PONTIAC

Service Craftsman News

No. 8 S-297

August, 1957

Fig. 1 Unconcealed Headlining

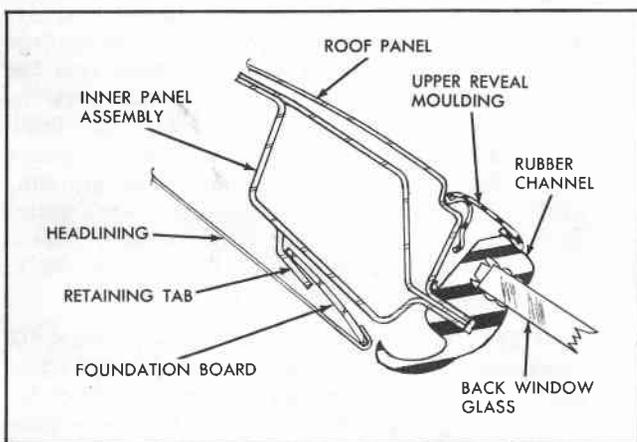
If a condition is encountered on 2711 and 2719 styles where the rear edge of the headlining is not concealed by the forward lip of the back window glass rubber channel, the condition may be corrected using the following procedure:

1. At affected area, as indicated in Figure 1, gently press rubber channel out of the way. Carefully grasp the rear edge of the headlining and pull the headlining down and rearward until the foundation board disengages from the retaining tabs in the rear roof bow. The retaining tabs may bend slightly during this operation.

Fig. 2 Compressor Front Support Reinforcement

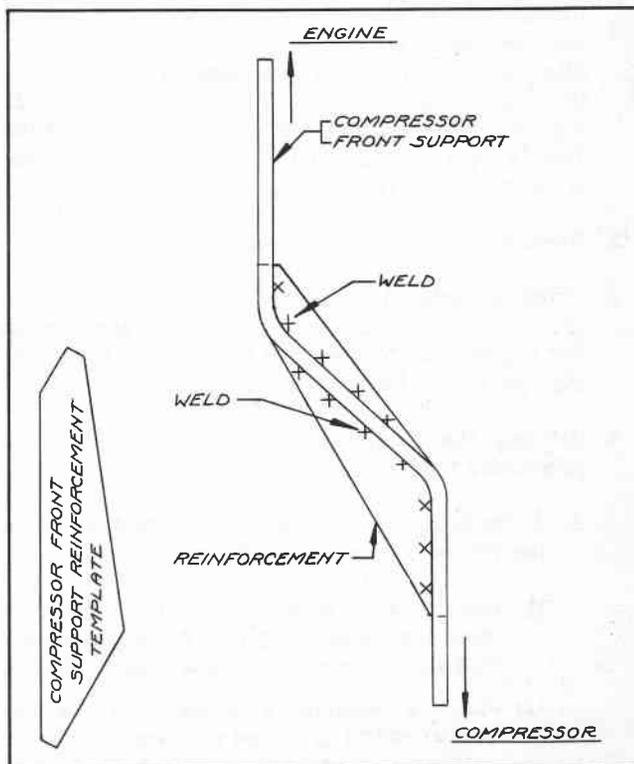
The vibrations experienced at 600-700 engine rpm may be eliminated as follows:

1. Remove the compressor front bracket.
2. Reinforce the compressor front bracket as shown in Fig. 2, with metal that is 3/16" or 1/4" thick using the template shown in the lower left portion of this same figure.

NOTE: This bracket should be reinforced so the metal is at the lower edge of the bracket when installed on the car.

Fig. 3 Production Cover Plate

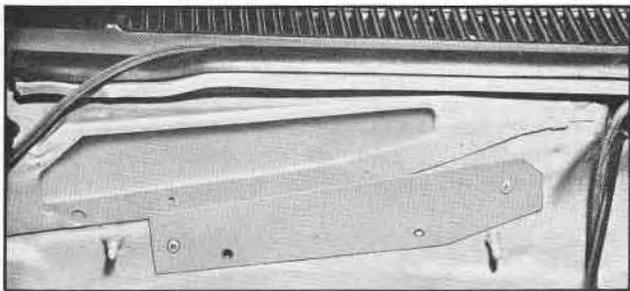
During the cooler weather, the owner may wish to have the plate positioned as shown in Fig. 3 to prevent outside air from entering the car.

partment into the inlet filter housing. This opening will be covered in production by a cover as shown in Fig. 3. Should the owner desire greater air cooling, it will be necessary to remove the filter housing and move this cover so as to form a baffle at the outside of the intake opening as shown in Fig. 4. Care should be used to seal between the dash and the cover to prevent water from entering the car.

Fig. 4 Position of Plate for Cooler Weather

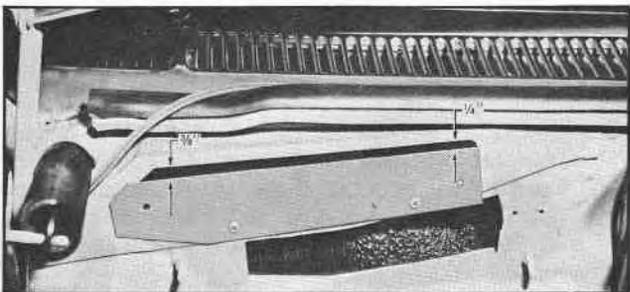
5. Place a bead of body sealer around the sides and lower outer edge of the 530753 cover. Place over the outside air opening to cover all but a gap 1/4", wide which would extend the entire length upper part of the hole (See Fig. 4).
6. Secure cover (530753) with sheet metal screws.
7. Replace air filter housing and adjust air valve cable.

Fig. 5 Drilling Balance Passage

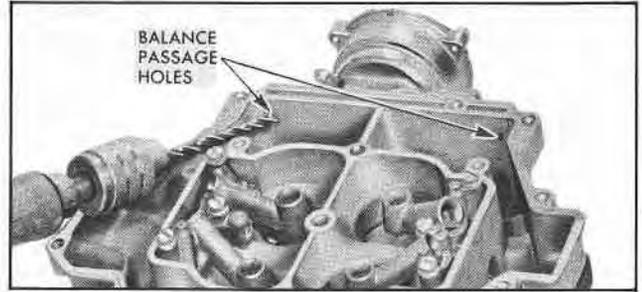
3. Remove fuel filter and inlet nut from carburetor air horn as a unit.
4. Using a 3/16" drill, drill out the balance passage holes (Fig. 5). Note: These holes are drilled at an angle and care should be used to see that drill does not contact other areas of carburetor while drilling. Position drill as shown. Remove all burrs and chips after drilling.

Fig. 6 Checking Float Level

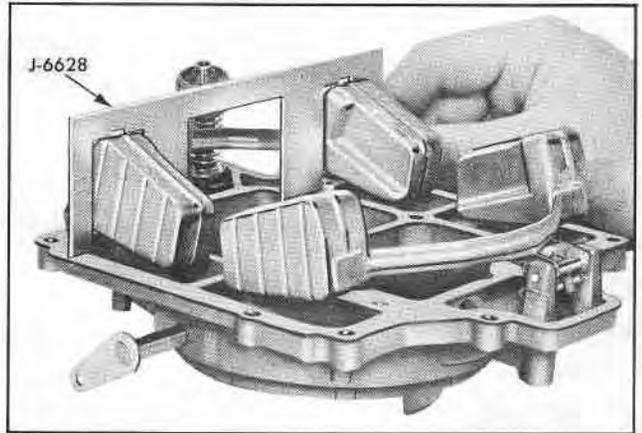
- (1) With air horn gasket in place and air horn inverted, position float level gauge J-6628 over floats as shown in Fig. 6 so that gauge is located against the curvature in base of carburetor air horn.
- (2) Bend float arms vertically at center so floats just contact gauge. The vertical height is $1\text{-}3/8" + 1/32"$.
- (3) If necessary bend float arms horizontally until each float pontoon is centered between gauge legs.
- (4) Repeat same adjustment on opposite float assembly.
- (5) With air horn inverted, lower edge of toe of float should be flush to $+1/16"$ from gasket surface. With gauge in position shown in Fig. 7, the two scribe marks on the gauge show required height of float toe necessary to ensure this clearance. If adjustment is necessary, hold float

Fig. 8 Adjusting Float Toe Height

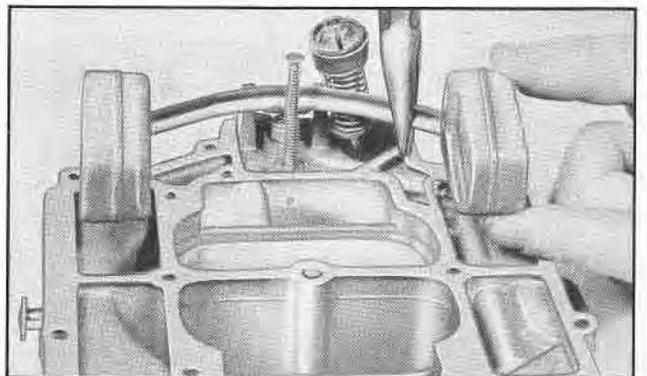
hanger adjacent to float pontoon, and with fingers bend toe of float up or down as required (See Fig. 8).

Fig. 9 Checking Float Drop

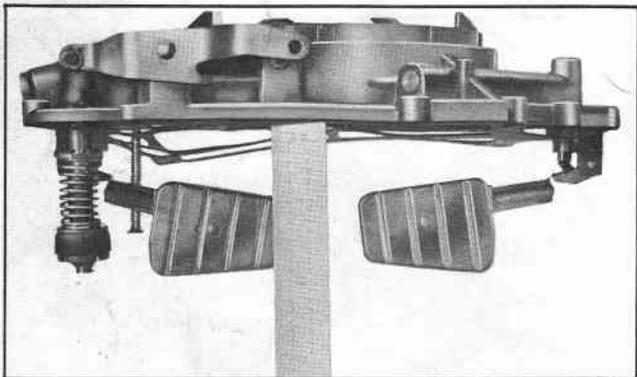
- (1) With float held in an upright position, check distance between air horn with gasket in place and the toe of float at end of radius as shown in Fig. 9. Float drop is correct when this distance is $1-13/16'' + 1/32''$. Note that this gauging is done at the toe of the float and NOT at the heel as shown in the 1957 Shop Manual.
- (2) If adjustment is necessary, bend float tang toward float needle seat to lessen drop and away from seat to increase drop.

Fig. 10 Shim Installed

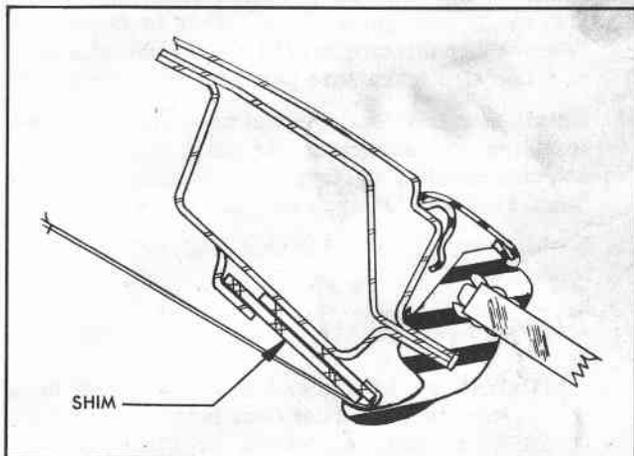
into a shim approximately four to six inches longer than the affected area. Trim the width of the shim so that it will be equal to the width of the foundation board plus the width necessary to obtain approximately 1/4 to 3/8 inch overlap, between the lip of the glass rubber channel and the headlining.

- 3. Rebend retaining tabs back into their original shape. Allow enough of an opening for shim to slide in readily.
- 4. Place shim between headlining and foundation board as shown in Figure 10.
- 5. Engage foundation board and shim into retaining tabs. Always work toward the center of a repaired area when re-installing headlining.
- 6. Using a flat-bladed tool, carefully pry lip of rubber channel over edge of headlining.
- 7. Reinstall rear quarter window garnish moldings on two-door styles.
